Response to Request for Further Information – Application EPR/MP3097FY/V006 Strongford STF

This correspondence is in response to the Environment Agency request for more supporting information received 07/04/26, regarding the variation application to our sludge treatment installation. This particular submission is in relation to Severn Trent's Sludge Treatment Facility at Strongford Sewage Treatment Works, ST12 9EX, referenced as permit number EPR/MP3097FY/V006. This is to be read in conjunction with Information previously submitted on 30/12/21, 21/06/24, 30/07/25, and 04/02/26, as confirmed via email 26/03/26.

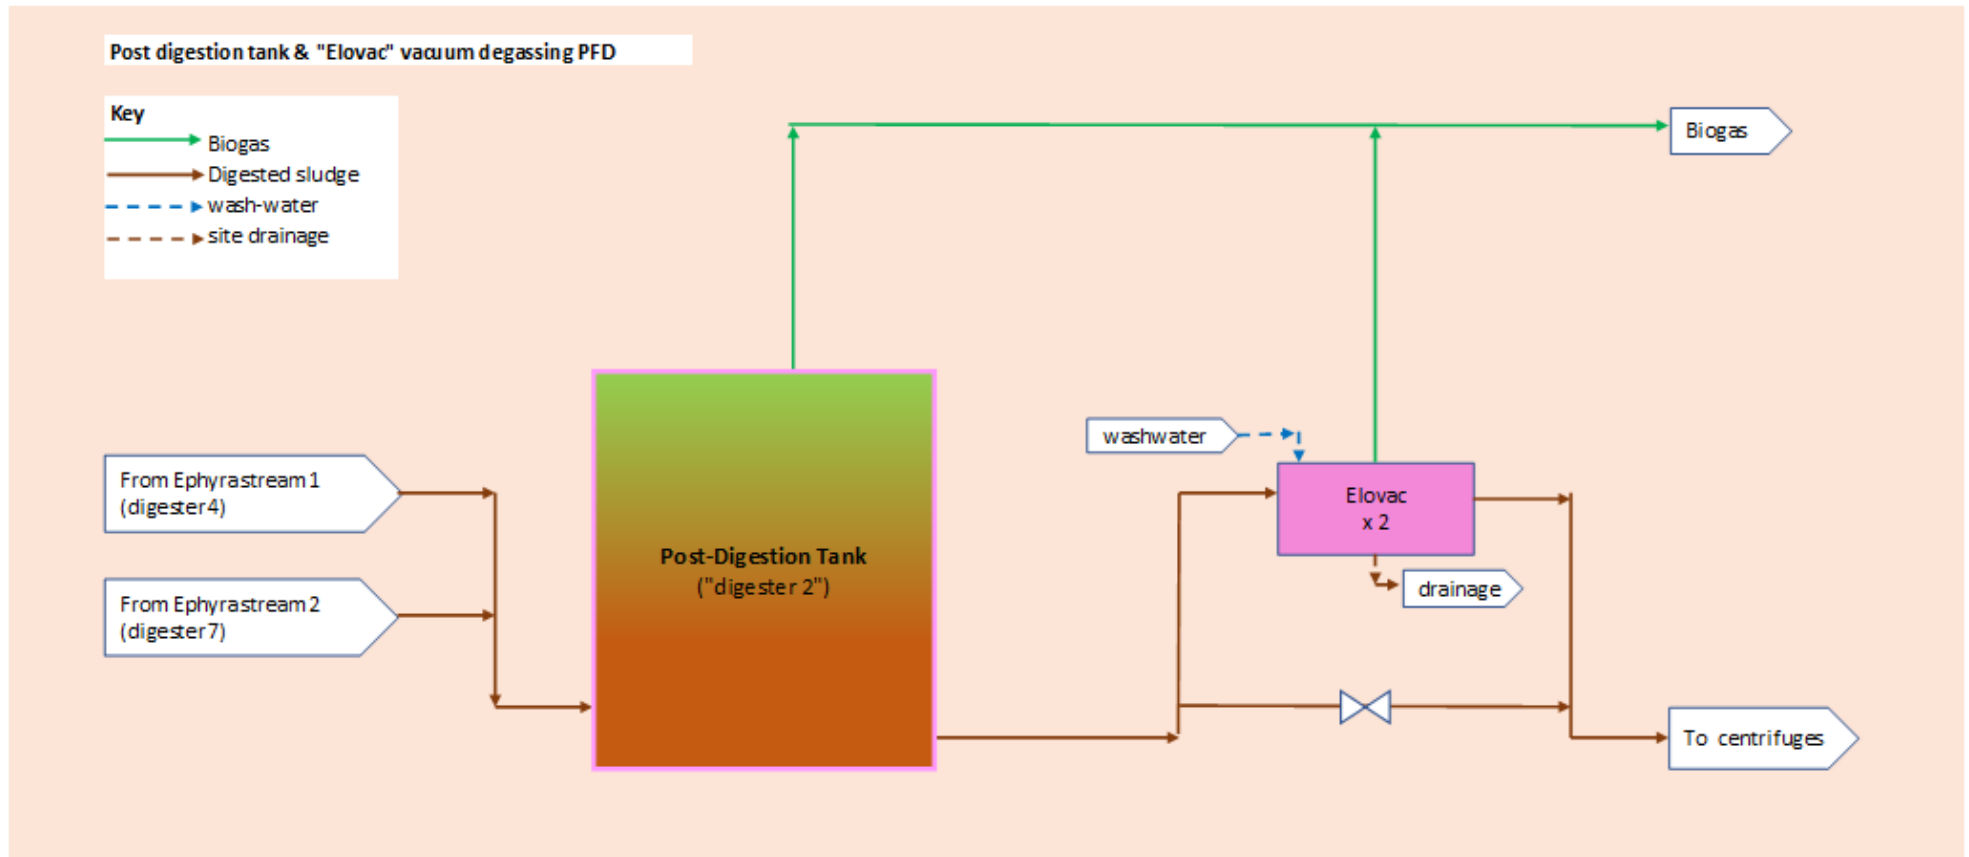
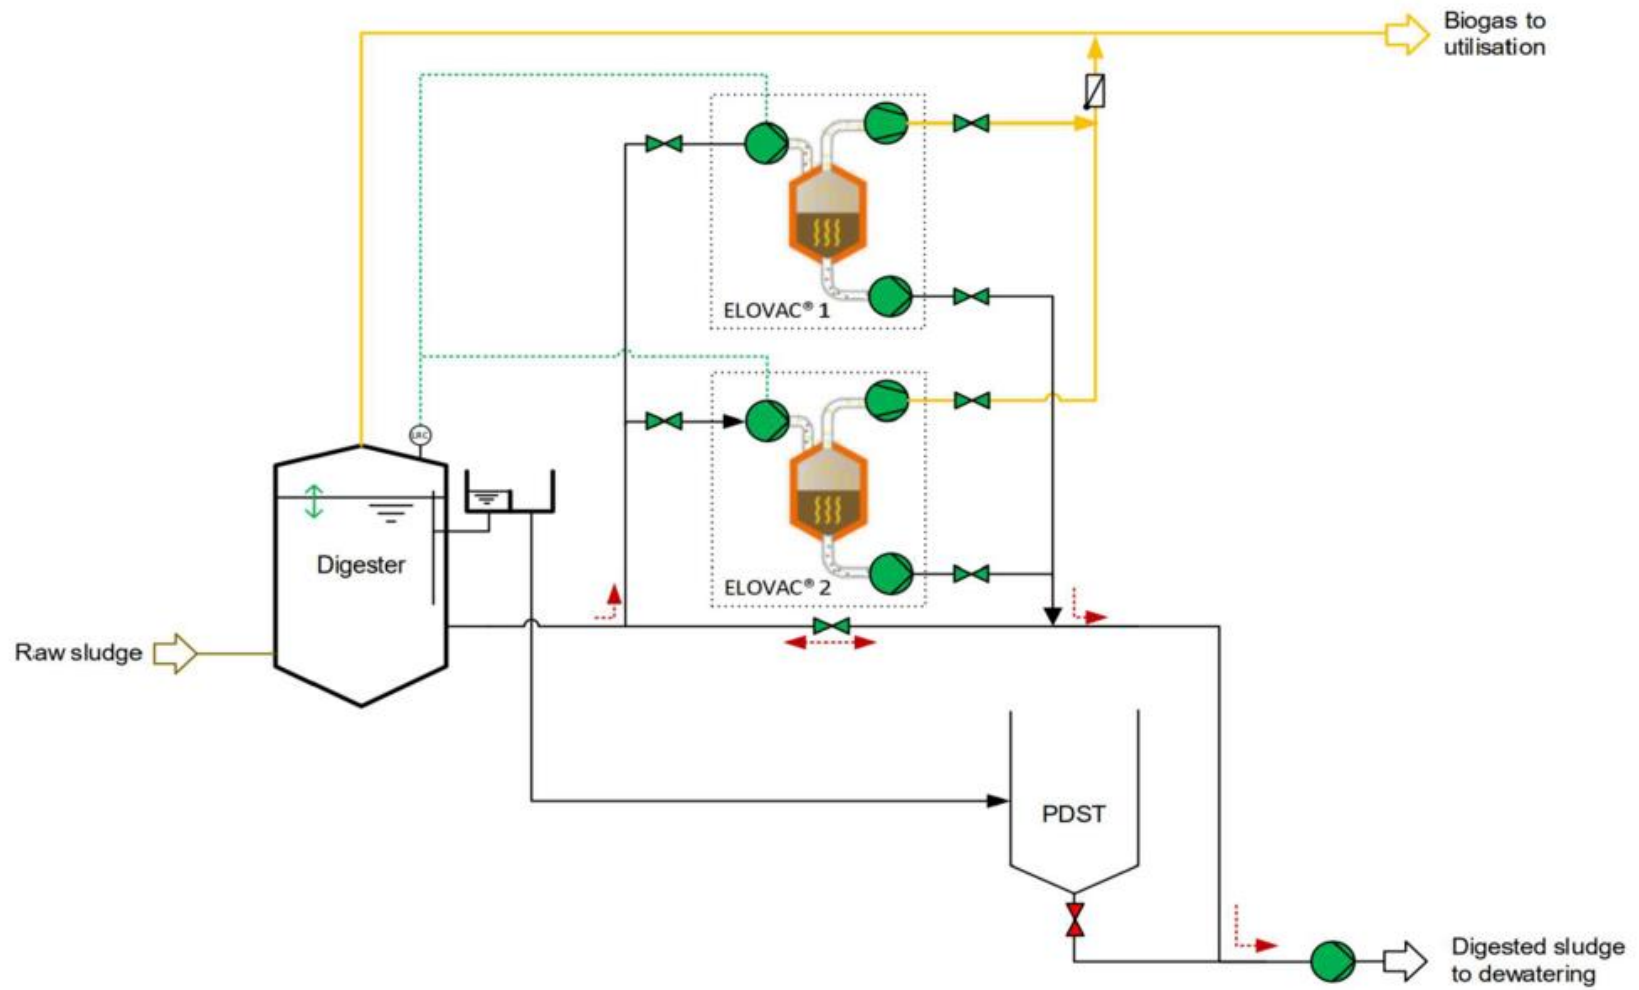
- f. Update your application to include a clear process flow on the vacuum methane degassing equipment.**
- g. Update your application to include a BAT assessment and assessment against Biological waste treatment: appropriate measures for permitted facilities"" for the vacuum methane degassing equipment, paying particular attention to BAT 14.**
- h. Provide a clear explanation of how the vents will operate.**

f) The process flow diagrams for the vacuum degassing process (ELOVAC) are as shown below.

The first diagram shows the location of the process in relation to the post digestion tank (formerly digester 2 at the site). Note that the Ephyra stream is the operation of the primary digesters in series mode, so there are only the two final digesters in each set which feed into the post digestion tank, which is fully enclosed.

The ELOVAC system itself is laid out as below, including the location of the valves and vents (note this is a generic drawing from the manufacturer and does not reflect the tank names etc of the Strongford site):

As such, there are no vents in routine, normal, use within the process. However, there are vents which are designed to be operated in order to carry out maintenance on the Elovac system. These are required to both introduce air safely into the vessel in order to bring it back to normal atmospheric pressure, and then also to allow for the vessel to be purged of any biogas remaining in the system to minimise the risks of biogas in an enclosed volume. This is carried out using automatic three-way valves which are only set to the atmosphere in the event of the plant being switched off. Normally, it is set in such a manner that it links the Elovac vessel and the biogas storage and treatment system.

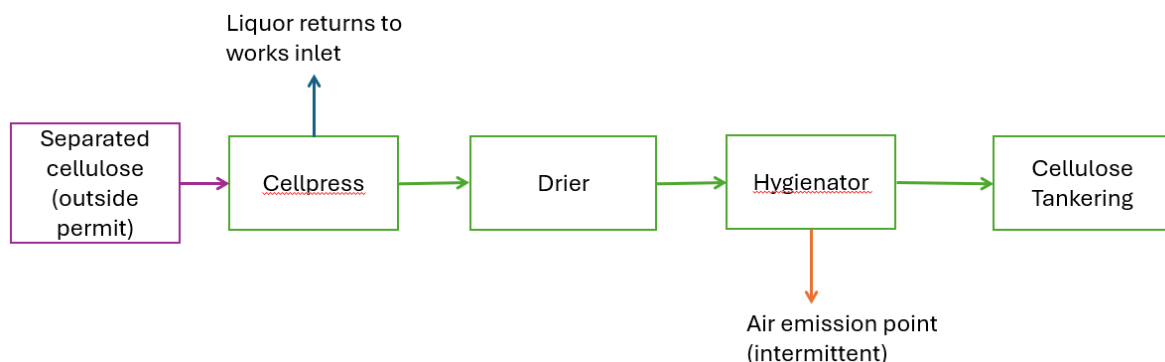
- a. **Update section '9.2 Appropriate Measures Assessment for Cellulose Recovery Plant' to provide detailed explanation of how the plant will meet the requirements of the 'Non-hazardous and inert waste: appropriate measures for permitted facilities'**
- b. **Confirm the EWC code to be accepted into the Cellulose Recovery Plant and explain why this code has been applied.**
- f. **Clearly explain in writing and identify within your process flow any emissions to air from diffuse, point source or other means from the cellulose plant.**
- g. **Explain how the carbon filter will be effective at treating emissions to air from the cellulose treatment plant and ensure that the carbon filter is included in all relevant management plans i.e.**

OMP and emission point plan.

f) The flow diagram for the permitted activities in the cellulose recovery plant is as below:

The Cellpress accepts the separated cellulose fibres from the unpermitted process. The Cellpress take the cellulose fibres and uses press plates to remove the bulk of water from the separated fibres (approx. 60% dry solids at this point). These liquors are returned to the works inlet for processing with the remainder of the UWWTD flow at the works. A screw conveyor transfers the fibres to the drier component and the hygienator. These use a combination of waste heat from the existing site boiler system and electrical heating to drive off any remaining entrained water and increase the dry solids content from around 60% to 90% in the cellulose fibres. This heating process operates at approximately 70C which effectively kills off entrained bacteria to sterilise the output and minimise the risk of any odour production. The fibres are then transferred to a sealed skip or tankered from site for offsite recovery or reuse. There is an intermittent release of heated air from the hygienator which would include any moisture generated.
